UNITED STATES PATENT AND TRADEMARK OFFICE

Office Action Summary

10/830,120

DETAILED ACTION

FIG. 1B
(RELATED ART)

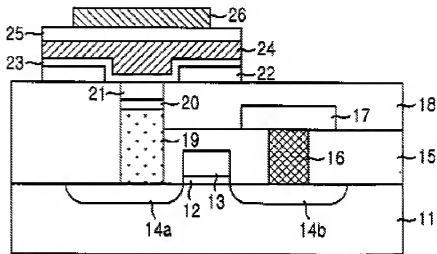
Regarding claim 1, Kweon et al. discloses a stack-type capacitor comprising:
a lower electrode on a diffusion barrier layer (Kweon et al., Fig. 1b → [23] and [24]);

a dielectric layer formed on the lower electrode (Kweon et al., Fig. 1b → [25]);
and an upper electrode formed on the dielectric layer (Kweon et al., Fig. 1b → [26]);

a first metal layer having a cylindrical shape and defining a cylindrical space (Kweon et al., Fig. 1b); and

In the embodiment depicted by Figure 1B of Kweon, Kweon does not explicitly state the layer 24 is a nitride aluminum layer. Kweon does however disclose when describing later embodiments that second metal layer of lower electrodes can comprise a nitride aluminum layer (Kweon et al, paragraph [0055] and Figure 4E --> second metal layer [38] can be TiAlN, first metal layer [37] can be Ru and the barrier layer [36a] can be TiN.);

It would be obvious to one of ordinary skill in the art at the time of the invention to form the multilayered capacitor structure with the claimed material layers disclosed by Kwion fig. 4E having a lower electrode with the cylindrical shape as shown in Figure 1b (above). The shape of a capacitor's electrodes is merely a matter of design choice. The capacitance of a capacitor is proportional to the surface area of the conducting plate and inversely proportional to the distance between the plates. It is also proportional to the permittivity of the dielectric substance that separates the plates. The capacitance of a capacitor is given by:
